SERVICE	2-15
	INFORMATION

Subject: Gear Selection Decal for Models 830 - 850

Illustration 1

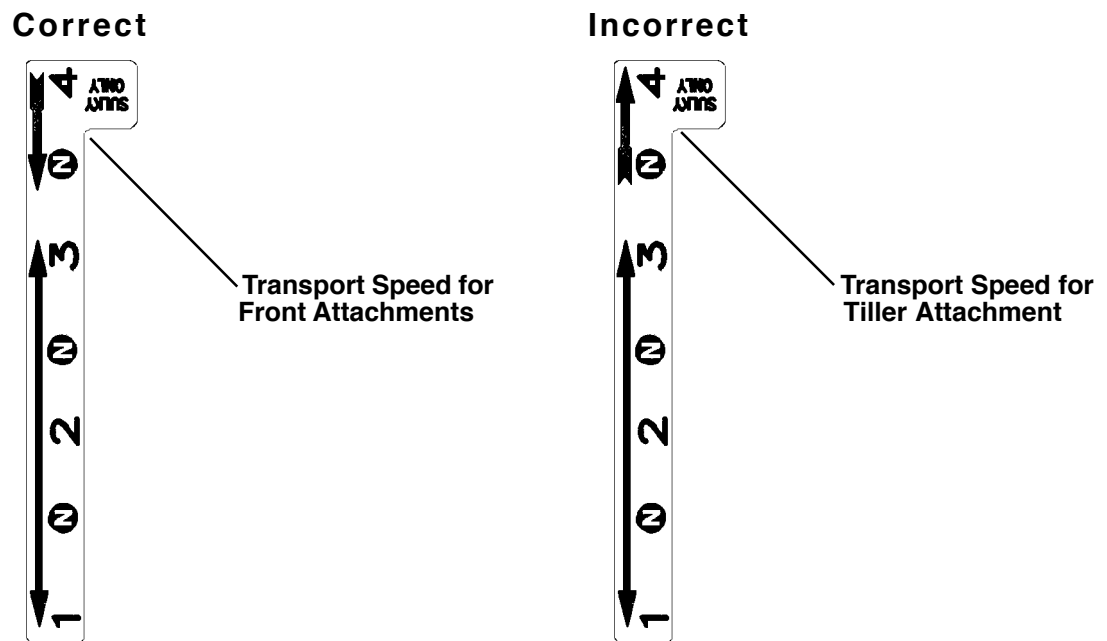
It has come to our attention that the gear selection decal for the model 830 - 850 may be incorrect on some of these tractors. This decal should show that the transport gear (4th Gear) be used only with front mount attachments. The incorrect decal shows the transport gear as being used with the tiller attachment. The decal that should be on these tractors can be identified by checking the decal on the unit to the decals pictured below.

We are requesting that all the units be checked for the incorrect decal and gap adjustment. If a tractor has the incorrect decal, the correct decal (p/n 580.57706) should be ordered. This decal will be sent as a no charge order to correct this situation.

Illustration 2

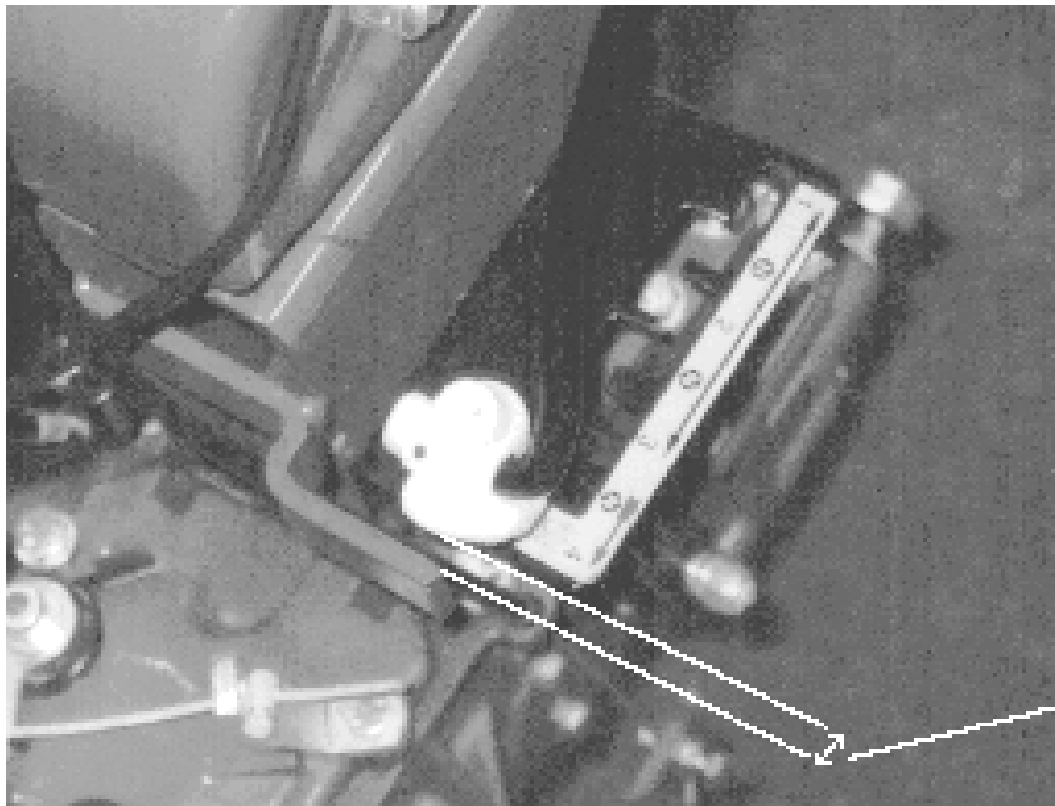
The transport gear lockout is to insure that the unit will not be allowed to shift into the transport gear while the handlebars are in the tilling mode. Some of the model 830 & 850 units may have too large a gap between the articulator and the stop bracket. The correct spacing for the lockout should be 2mm-6mm between the articulator and the stop bracket when the unit is set up as a tiller and the gear selector is in the neutral between 3rd and 4th gear. (see illustration 2) This will insure that this unit will not be allowed to shift into the transport gear while tilling.

A 2mm to 6mm Gap should exist between the articulator and stop bracket

To adjust the gap between the articulator and stop bracket, strike the stop bracket with a hammer and bend into position.
